Consider/Approve Change Order No. 6 with Morel Construction for the Support Operations Center Project – BG 23-173.

CHANGE ORDER INFORMATION:
Change Order Number: 006
Date: 8/15/2024

Project: KCSD Support Operations Center

1 SECTION
SCALE: 1" = 1'-0"

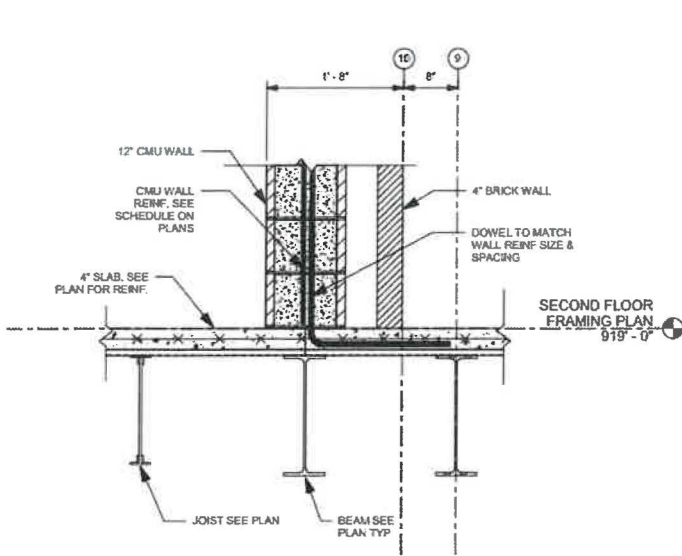
Provide a masonry control joint in the CMU wall and masonry veneer where the wall transitions from bearing on the concrete foundation wall and bearing on the elevated floor slab over the W shape beam per detail 1 and 2.

Provide a masonry control joint in the CMU wall and masonry veneer where the wall transitions from bearing on the concrete foundation wall and bearing on the elevated floor slab over the W shape beam per detail 1 and 2.

4 SECTION
SCALE: 1" = 1'-0"

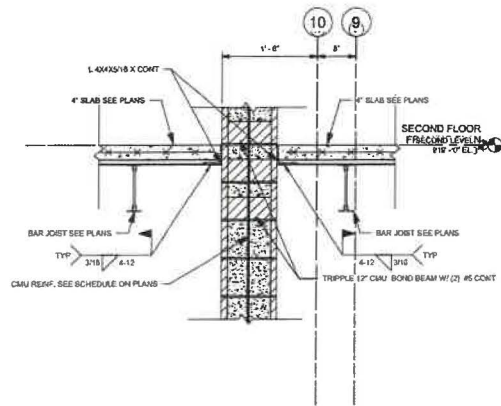
The structural detail indicated above occurs over the IT area only.
See section 4/S-311 indicating the load bearing CMU is continuous to the top of the foundation wall.

The structural detail indicated above occurs over the IT area only. See section 4/S-311 indicating the load bearing CMU is continuous to the top of the foundation wall.

The elevated floor slab is continuous to the face of the load bearing CMU wall per detail 4/S-311. Brick veneer sits on top of floor slab with CMU veneer extending to the bottom of floor slab. CMU veneer must be installed to bottom of floor slab prior to installation of the brick veneer from the elevated floor slab. See note on detail 3/AE307 end of this response.

7 SECTION
SCALE: 1" = 1'-0"

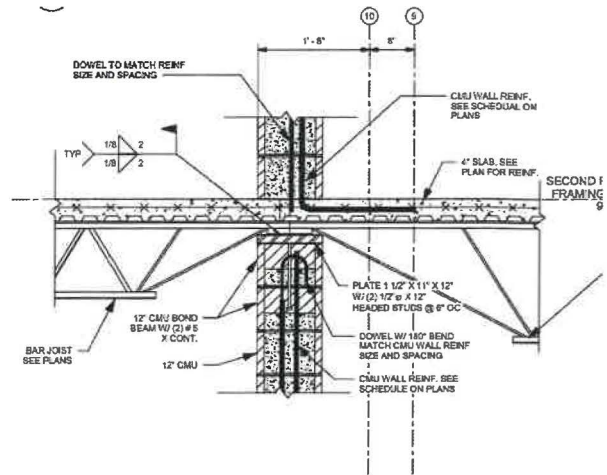
Detail 7/S-306 is intended at door opening 202A where the floor slab would have to pour through the door threshold.

Detail 7/S-306 is intended at door opening 202A where the floor slab would have to pour through the door threshold.

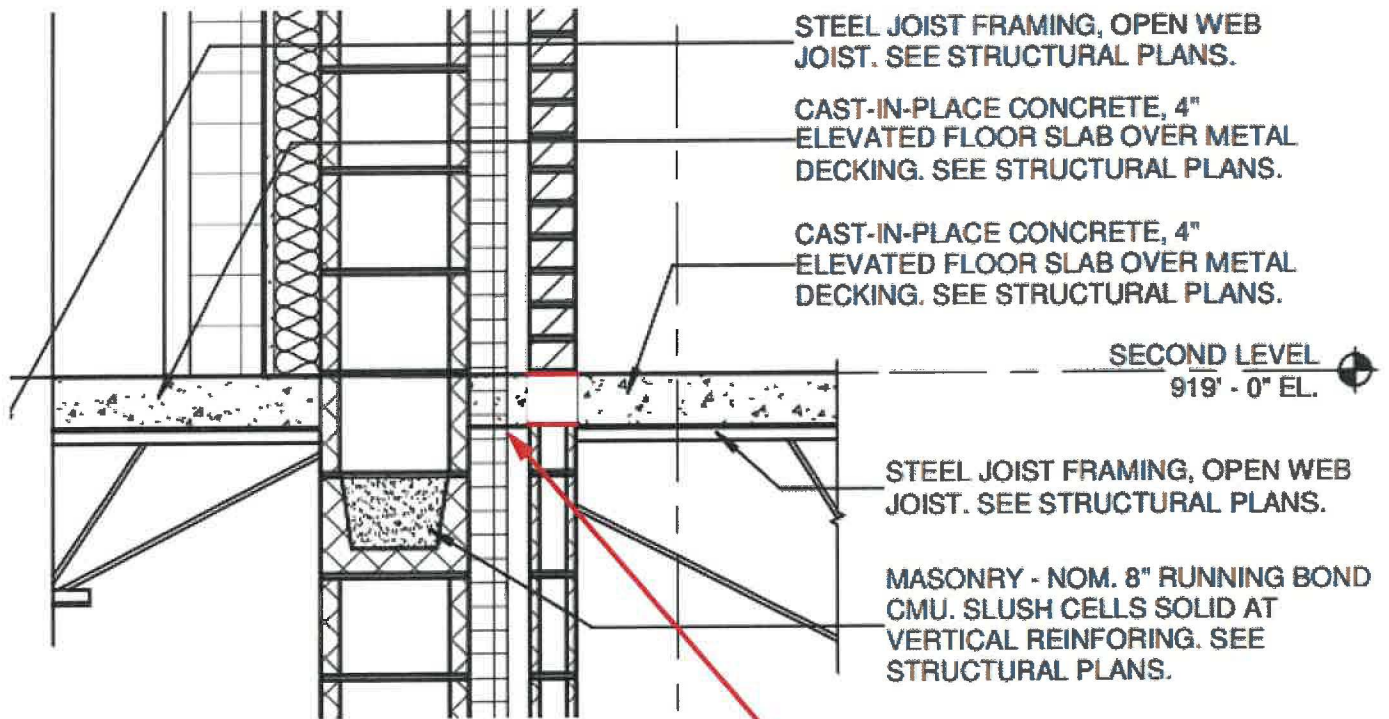
Elevated floor slab is continuous to the face of the load bearing CMU wall. Brick veneer sits on top of floor slab with CMU veneer extending to the bottom of floor slab.
